BCC 2018-077
March 28, 2018

Re: Draft HHRA OU2 and OU3, BERA OU2 and OU3

1978 photo showing buried drum

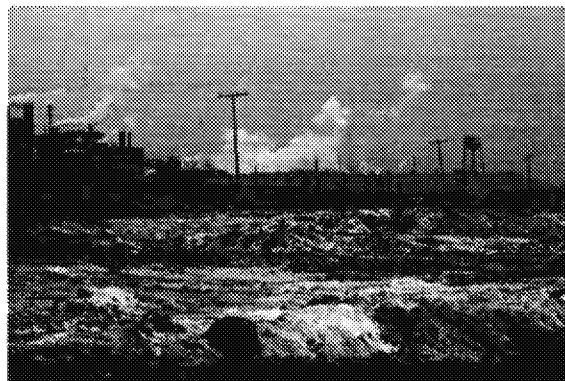
Photos from DEQ files and photos provided by past workers show that drums were buried in these dumps in 1978 and 1992. This has not yet been evaluated.

1992 DEQ file photo, showing waste buried in groundwater

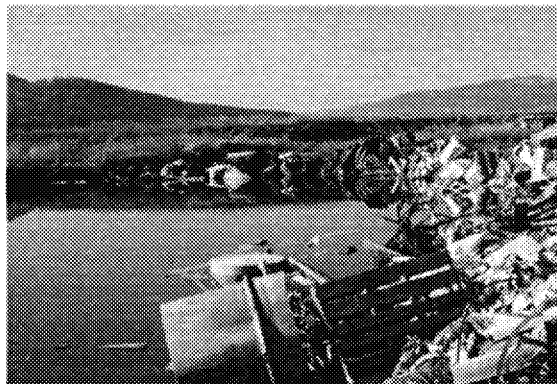
A large flood has the potential to erode 53 years of accumulation of sludge, ash and industrial waste that has yet to be properly characterized. These photos are evidence of the materials that may be currently affecting groundwater and are certainly vulnerable to floods.
